AREAS OF MODIFICATION BETWEEN APPROVED DRAINAGE GRADING PLAN AND ACTUAL AS-BUILT

Believers Center of Albuquerque Grading / Drainage Plan

Believers CENTER OF ALBUQUERQUE
NEW CHURCH FACILITY
1-40 Frontage Rd. & Waterfall SE
ALBUQUERQUE, NEW MEXICO

sheet title
GRADING PLAN

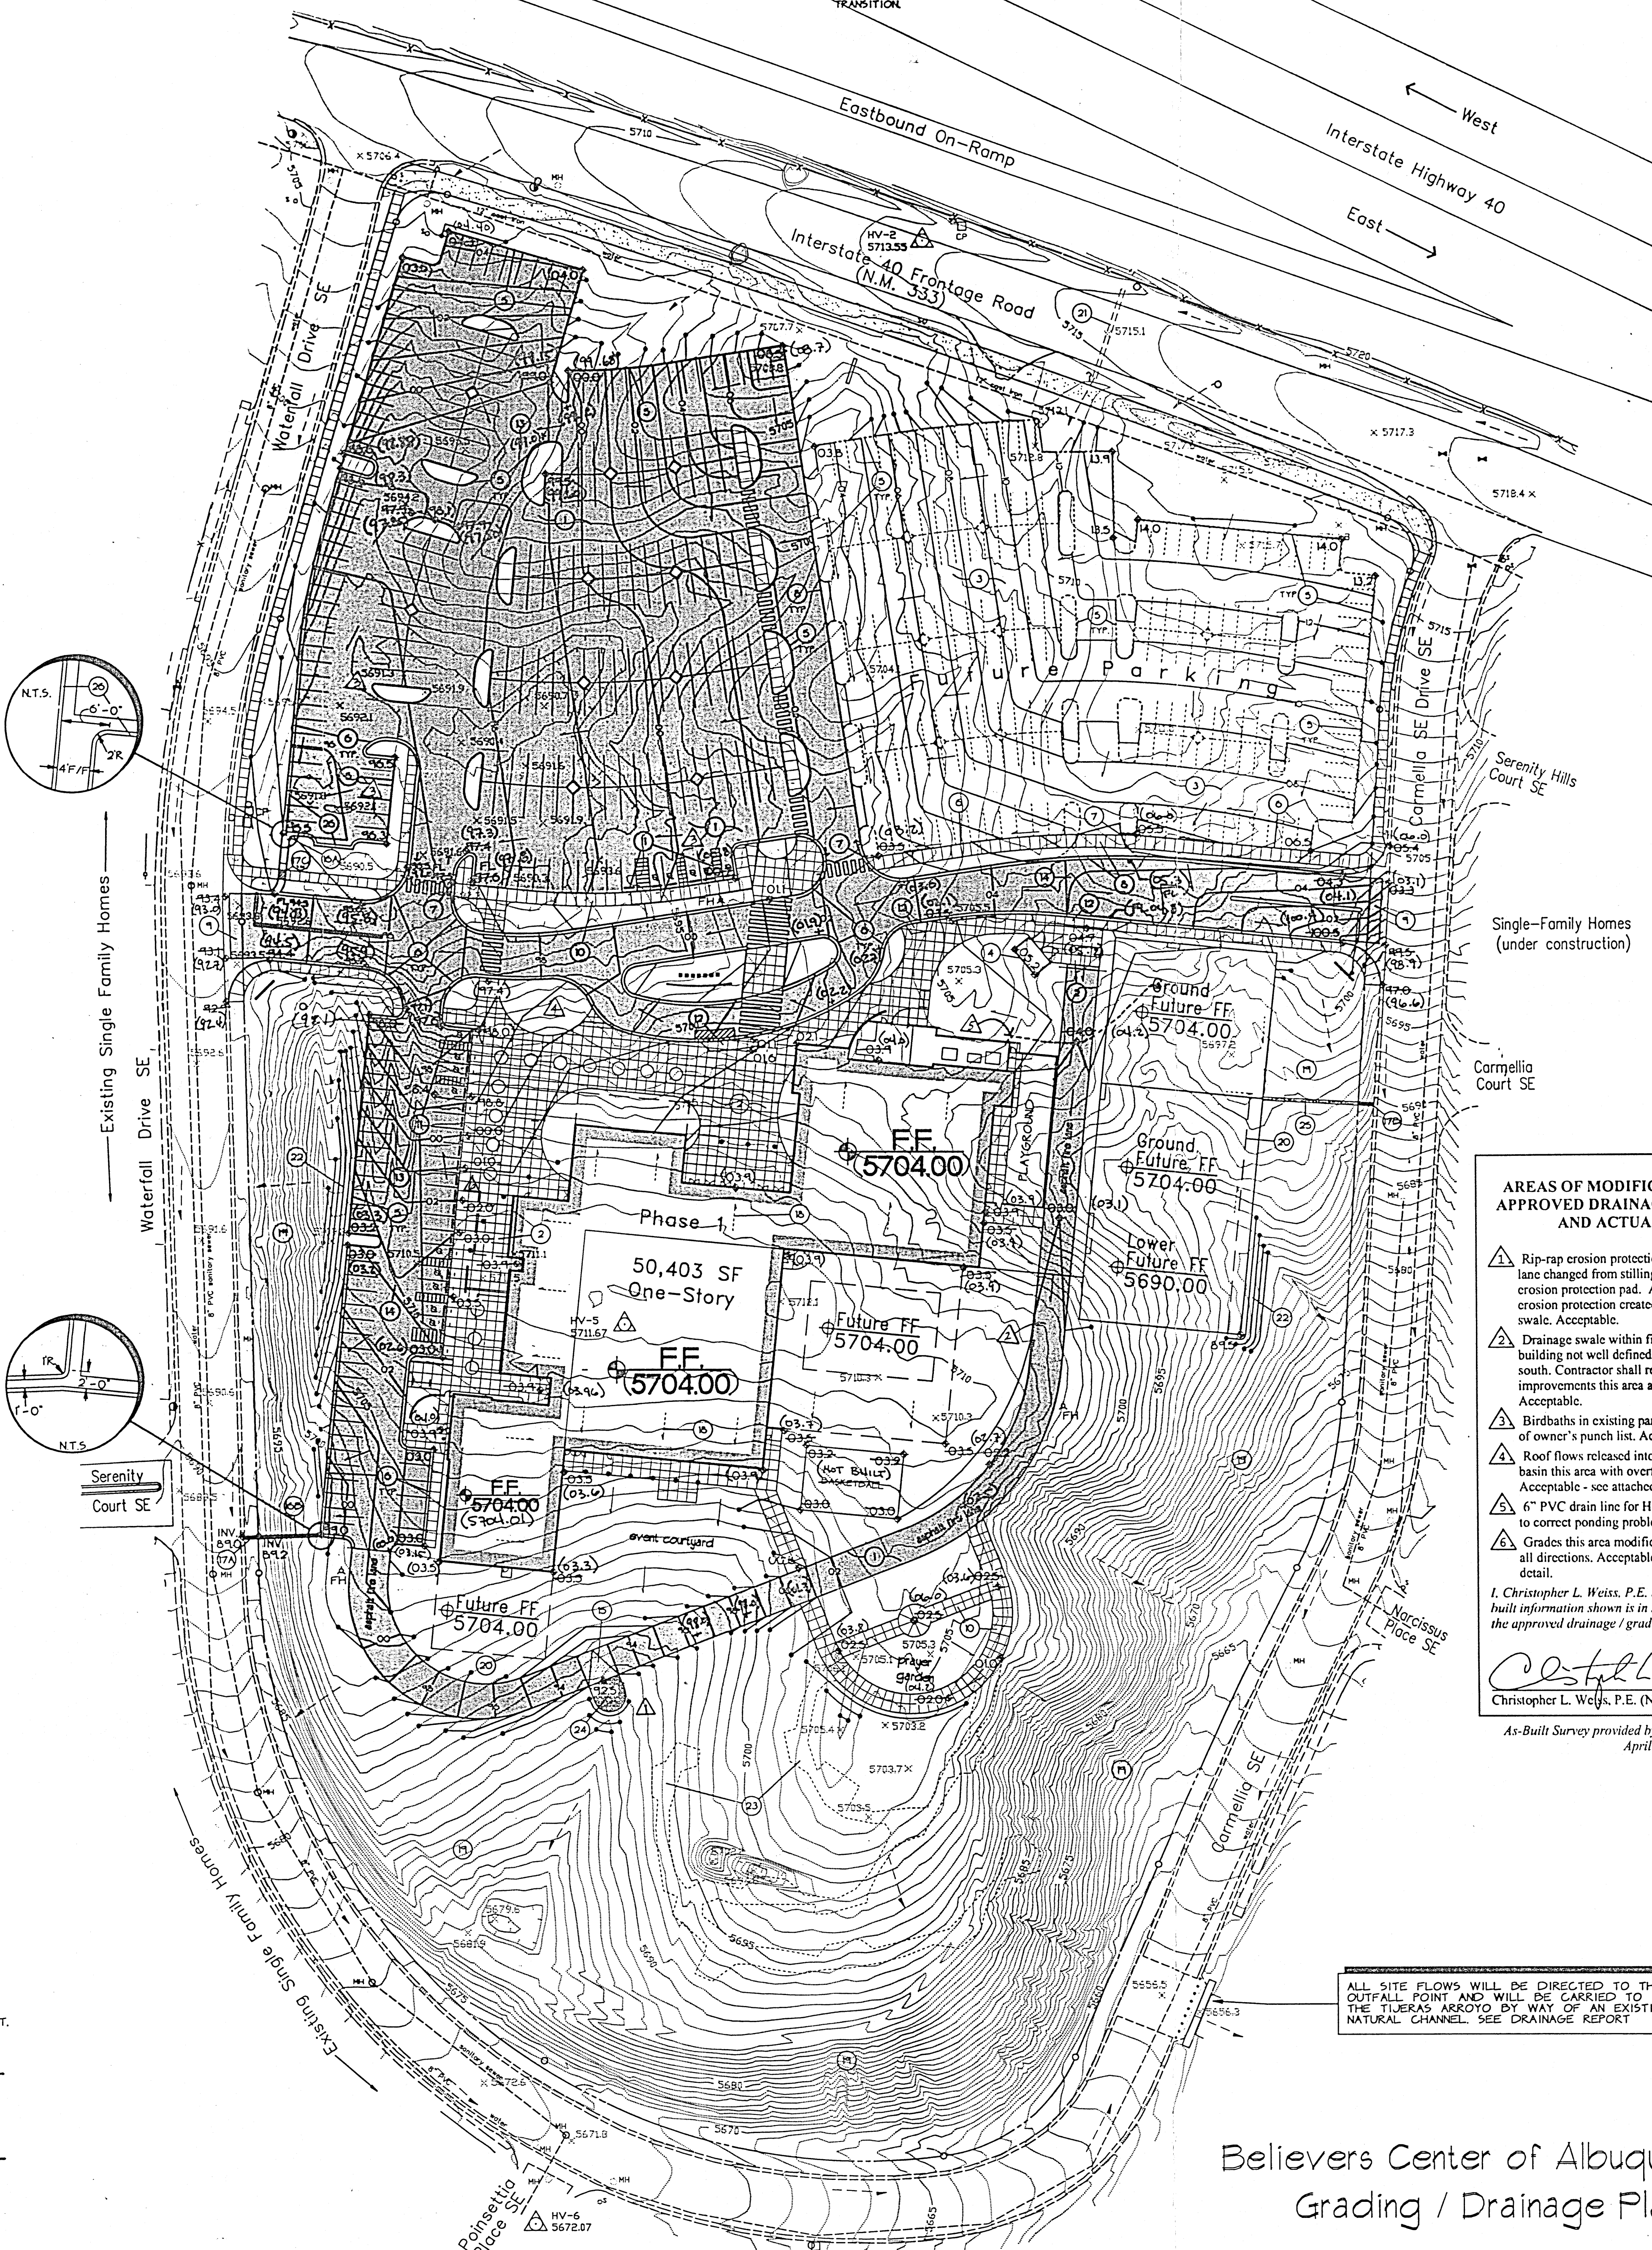
- Rip-rap erosion protection at low spot on fire access lane changed from stilling basin configuration to erosion protection pad. Additional landscaped erosion protection created within natural drainage swale. Acceptable.
- Drainage swale within fire access lane on east side of building not well defined. Flows will follow roadway south. Contractor shall regrade for further improvements this area as part of owner's punch list. Acceptable.
- Birdbaths in existing parking to be removed as part of owner's punch list. Acceptable.
- Roof flows released into landscaped water harvesting basin this area with overflow onto paved parking. Acceptable - see attached as-built detail.
- 6" PVC drain line for HVAC courtyard area installed to correct ponding problem. Acceptable.
- Grades this area modified to allow HC access from all directions. Acceptable - See attached as-built detail.

I, Christopher L. Weiss, P.E. hereby certify that the as-built information shown is in substantial compliance with the approved drainage / grading plan.
